# Dekko Garments Ltd

# Observation

**Structural System: Main Production building**

Horizontal bracing layout

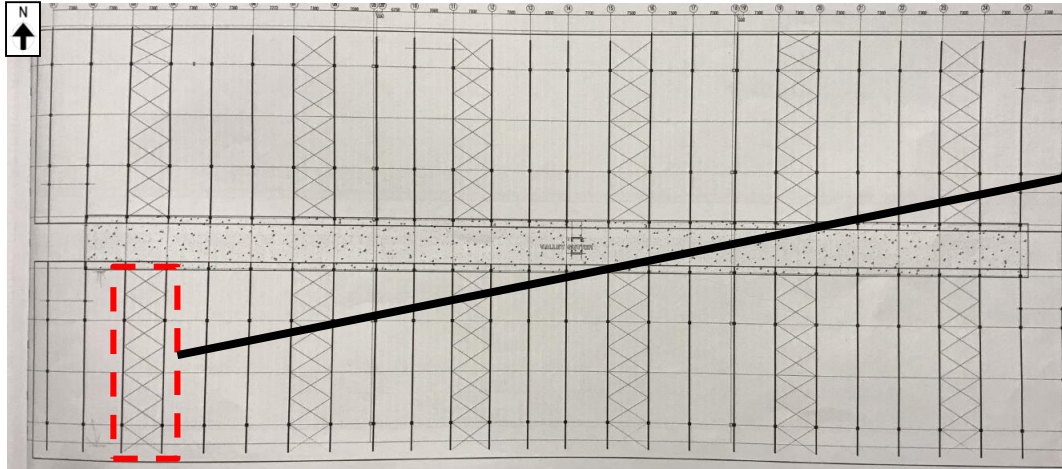
On the marked location, horizontal bracing was not observed

Bolt missing at some splice locations of beam on top floor

At one location horizontal bracing was not found on site. At some splice locations of beam on top floor bolt was found missing. Factory is required to install the missing elements as shown in the as-built drawings.

**Significant gap in steel beam and RC  
column joint at several locations**

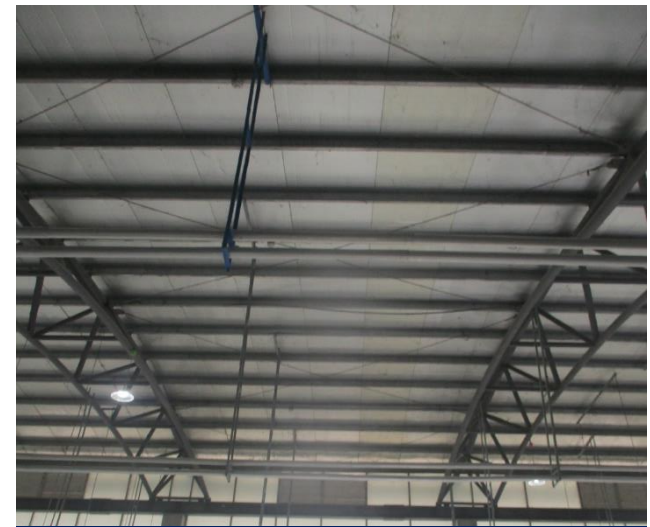
Significant gaps were found at top floor steel beam to RC column joint. Factory engineer is required to carry out suitable remedial works.

Position marking of the steel roof structure.

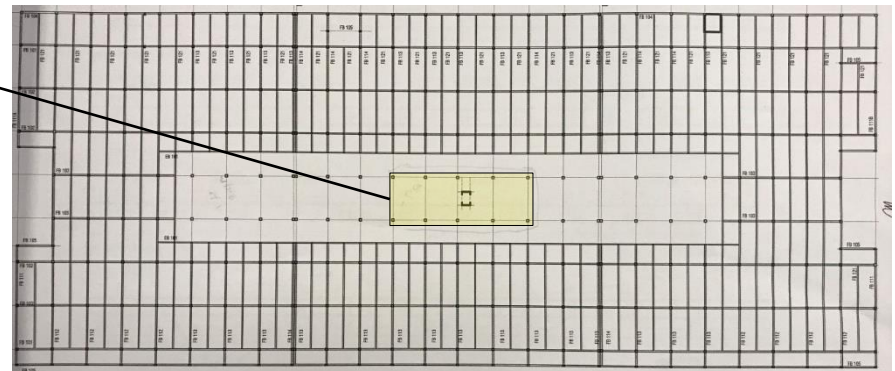
No RC column-steel beam connection detail and sectional detail of steel beam were provided in the as-built drawing.

The dimension was not given for horizontal cable bracing.

No connection detail was found in drawing for the steel roof structure around the lift.
